IFB No. **17-36 Flinn Middle School HVAC, Lighting and Ramp Renovations**

RE: **ADDENDUM NO. 4**

RE: ADDENDUM #4

PROJECT: FLINN MIDDLE SCHOOL HVAC, LIGHTING AND RAMP RENOVATIONS
ROCKFORD PUBLIC SCHOOLS 205
ROCKFORD, ILLINOIS

Sheet MD1.6

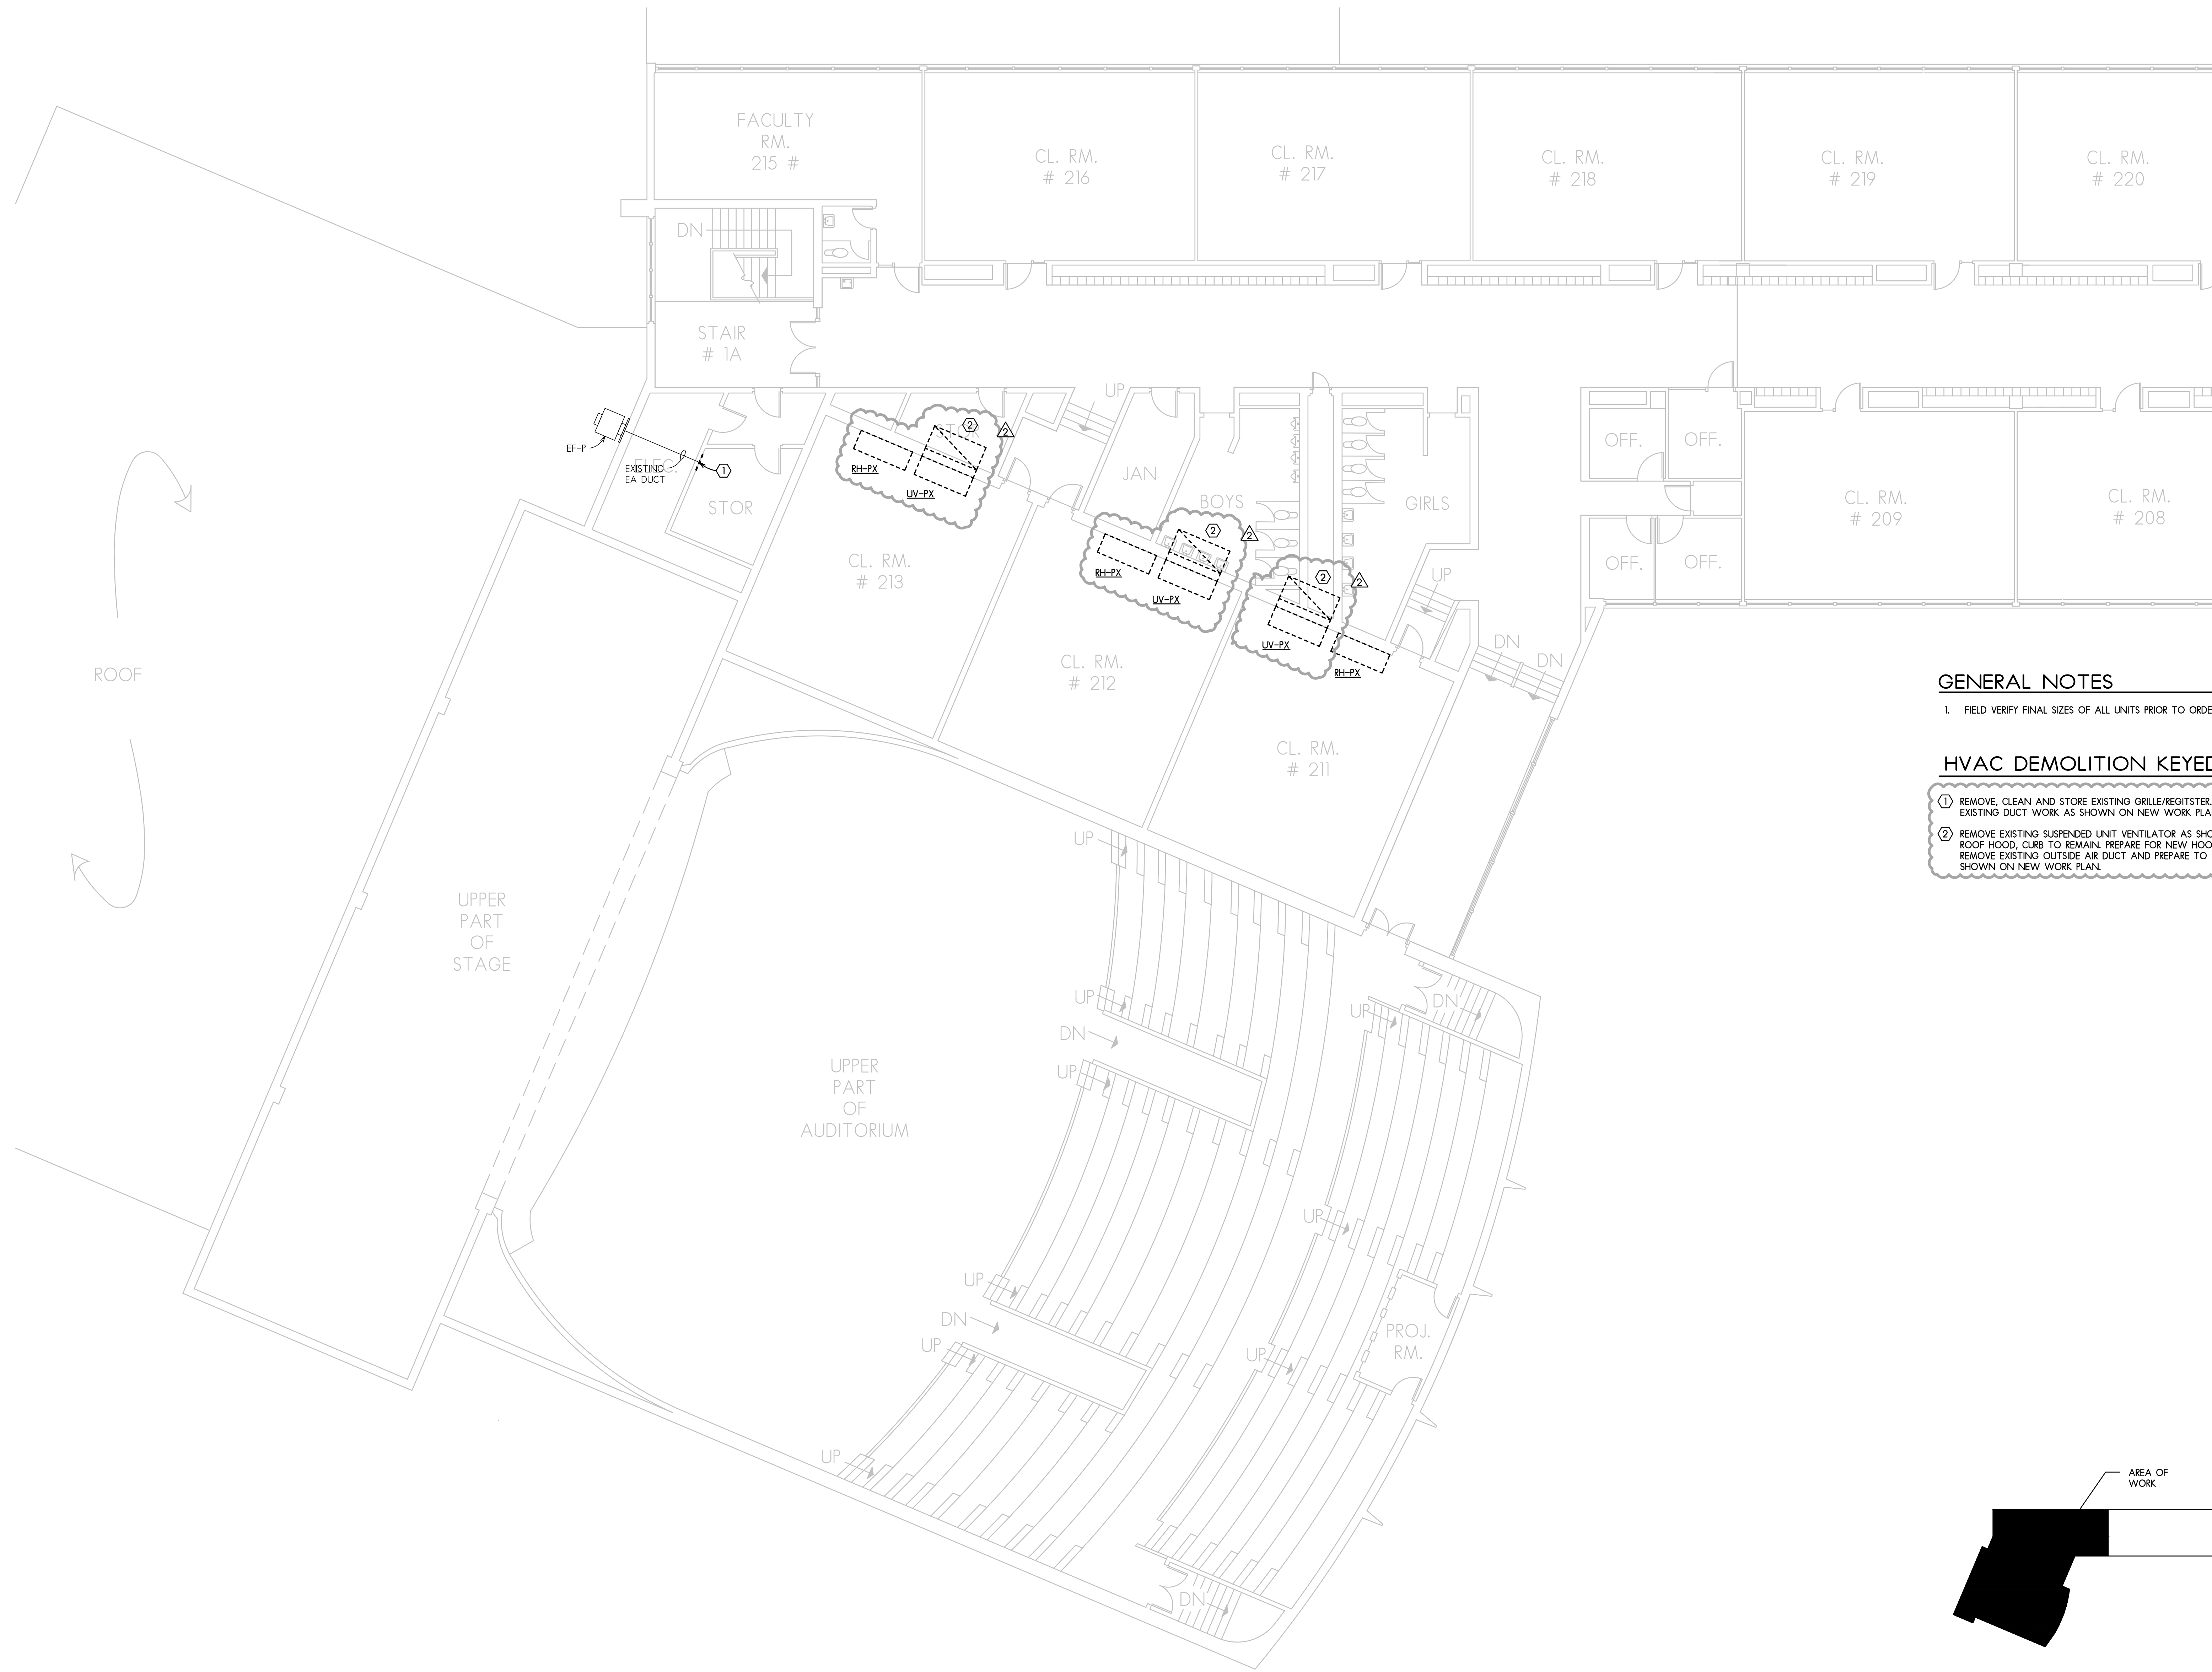
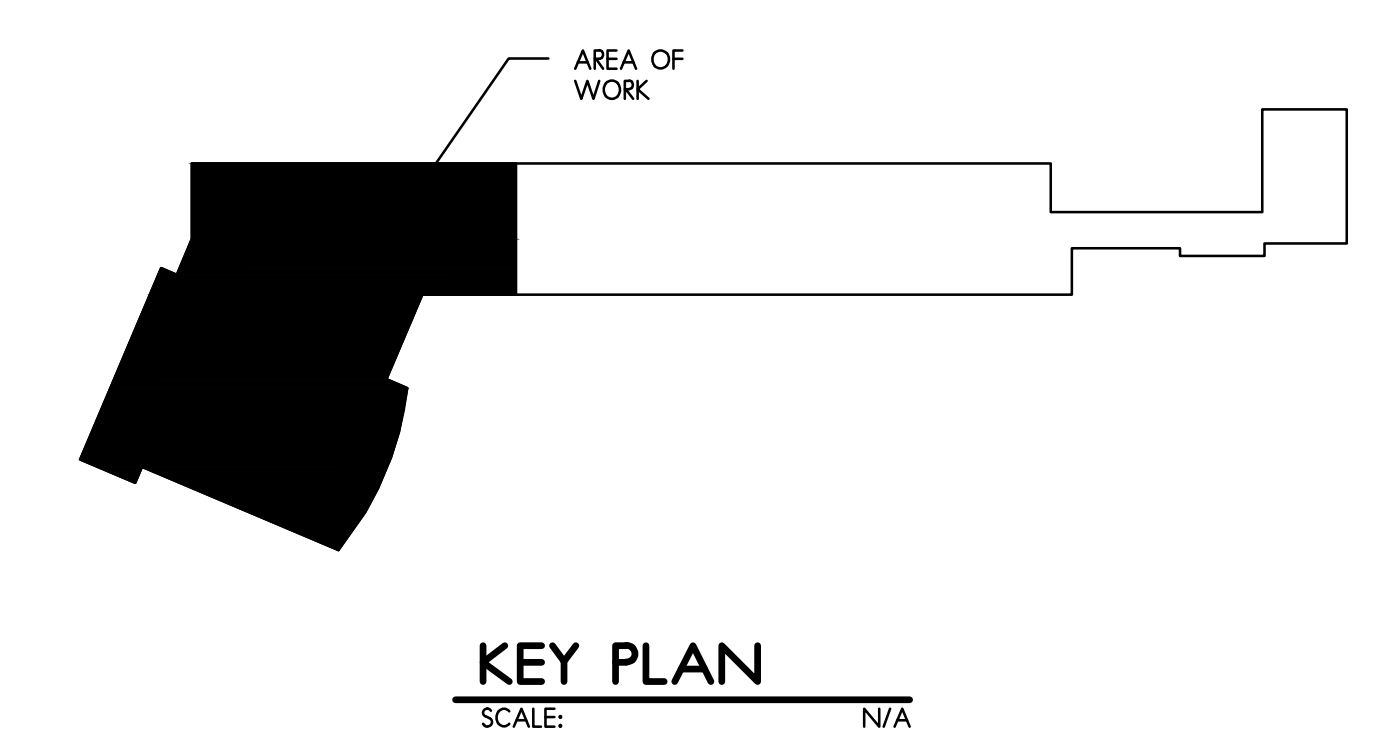
- A. Sheet has been revised and re-issued.

- ① REMOVE, CLEAN AND STORE EXISTING GRILLE/REGISTRER. PREPARE TO EXTEND EXISTING DUCT WORK AS SHOWN ON NEW WORK PLAN.
- ② REMOVE EXISTING SUSPENDED UNIT VENTILATOR AS SHOWN. REMOVE EXISTING ROOF HOOD, CLRB TO REMAIN. PREPARE FOR NEW HOOD AND CLRB ADAPTER. REMOVE EXISTING OUTSIDE AIR DUCT AND PREPARE TO INSTALL NEW UNIT AS SHOWN ON NEW WORK PLAN.
